[Issue No.] GOT-A-0016-A

[Title] Changes in License Key Appearance (GT15-SGTKEY-U) for GT SoftGOT1000

[Relevant Models] GOT1000 Series

Rating plate	GT15-SGTKEY-U	
	New	Old
Dimensions	16.5 (0.65) (A) 7.2 (0.28) (B) [mm] (inch)	24.0 (0.94) (A) 11.0 (0.43) (B) [mm] (inch)
Number	BD992D <u>233</u> H01	BD992D <u>214</u> H01

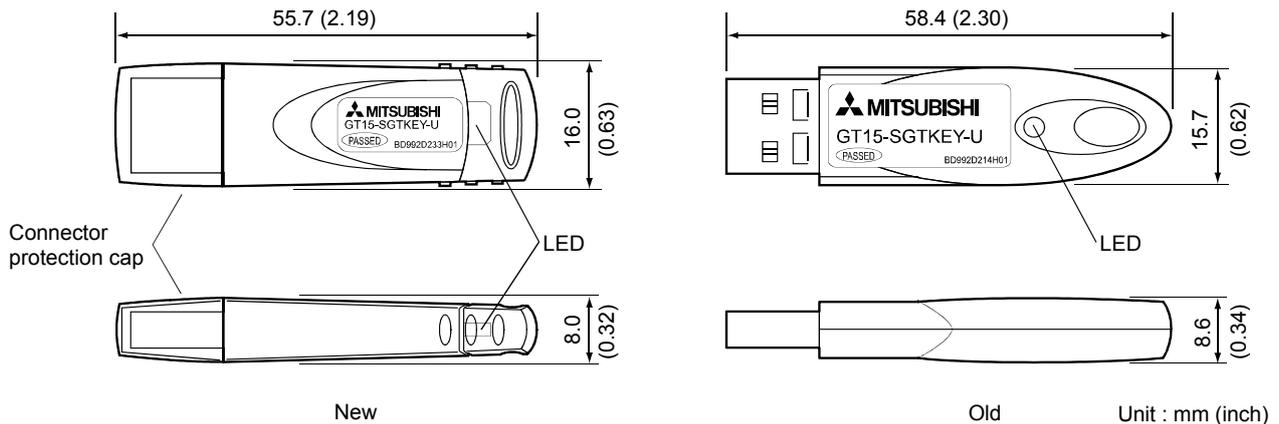
The external appearance of the GT15-SGTKEY-U (for USB port) for GT SoftGOT1000 will be changed.

The color of the license key is changed from purple to black, and the LED status becomes easy to see compared to the old license key.

The new license key has a connector protection cap.

No electric performance specifications are changed compared to the old license key, and you do not have to change the operating environment of GT SoftGOT1000.
